Service Bulletin

Subject: Loose Sana Grid Hardware

Models: International XYCFHC118/218/318, XYCFRE118, XYSCHF218/318, XYSCHFRE218/318, YSCFHC218/318, YSCFHC214, 2FQE80, FPRE380/680, XFPRE280/380/480/580

Figure 2

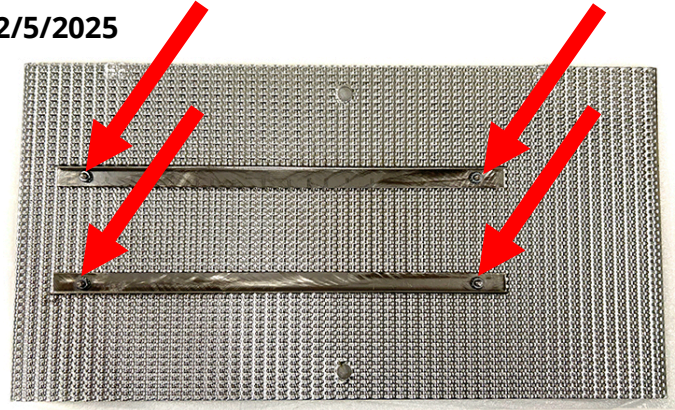
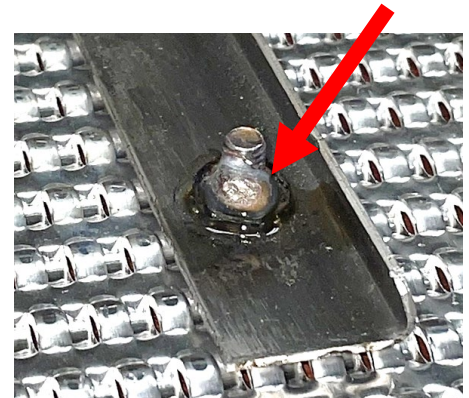
Hardware on some Sana Grid screens with stiffeners, manufactured with serial #'s starting with 2311 through 2501, may have loosened up during shipment and fallen off in the filter pan. If this hardware is pumped into the filter pump, it may damage the pump.

1. Remove the Sana Grid screen from the filter pan
2. Dispose of the Sana Grid screen. Ensure the old screen **DOES NOT** remain in the restaurant and is disposed.
3. Replace with the new 1081029SP or 1067330SP Sana Grid screen with welded nuts (see Figure 2).
